Access Compliance Report

Public Rights-of-Way

(Curb Ramps)

Intersection ID: 49507	Main Street: OSCEOLA_LN	Cross Street: ANKENY_CT	Location: S
ADA ID: F61D8D572A6B	Ramp Type: PerpDiag	Initial Pass/Fail: Fail	Overall Compliance: No
Severity Score: 28.75			
Codes/Mitigation Info/Possible Solution		Field Measurements/Component Compliance

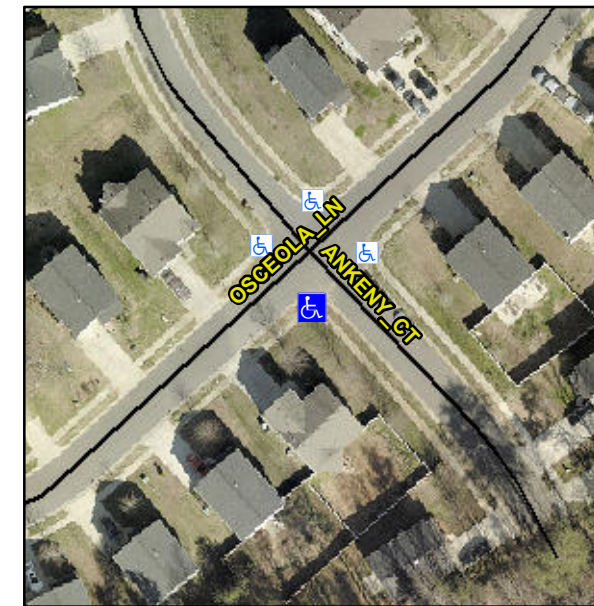
R304.2.2, R304.5.3, R302.7

Compliance	Description	Data	Compliance	Description	Data
N/A	Ramp Length (in)	47.0	No	Ramp Slope (%)	11.8
Yes	Ramp Width (in)	48.0	No	Ramp XSlope (%)	2.3
N/A	Flare Type LT	N/A	N/A	Flare Type RT	N/A
N/A	Flare Slope LT (%)	N/A	N/A	Flare Slope RT (%)	N/A
N/A	Flare Traversable LT?	N/A	N/A	Flare Traversable RT?	N/A
N/A	Landing Length (in)	N/A	N/A	DWS Provided?	N/A
N/A	Landing Width (in)	N/A	N/A	DWS Contrast?	N/A
N/A	Landing Slope (%)	N/A	N/A	DWS Length (in)	N/A
N/A	Landing X Slope (%)	N/A	N/A	DWS Full Width?	N/A
N/A	Landing Curb? (Y/N)	N/A	N/A	DWS Offset (in)	N/A
N/A	Shared Landing?	N/A			
N/A	Gutter Ponding?	N/A	N/A	Gutter Slope (%)	N/A
N/A	Gutter Lip Ht (in)	N/A	N/A	Gutter X Slope (%)	N/A
N/A	Painted X Walk1?	No	N/A	Painted X Walk2?	No
	X Walk 1 Direction	To NW		X Walk 2 Direction	To NE
N/A	X Walk 1 Width (in)	N/A	N/A	X Walk 2 Width (in)	N/A
	X Walk 1 Slope (%)	3.2		X Walk 2 Slope (%)	1.8
	X Walk 1 X Slope (%)	3.4		X Walk 2 X Slope (%)	4.2

N/A	Ramp inside XWalk1?	N/A	N/A	Ramp inside XWalk2?	N/A
	Road Slope (%)	3.3	N/A	Clear Space?	N/A
	Road X Slope (%)	3.4	N/A	Clear Space to XWalk (in)	N/A
N/A	Any Obstructions?	N/A	N/A	Storm Grate/Utility Hazard?	N/A
	Obstruction Type			Storm Grate/Utility Type	
		N/A			N/A
		No		Surface Condition? (G/P)	Poor

Remove & Replace Curb Ramp With Two New Directional Ramps or Equivalent.
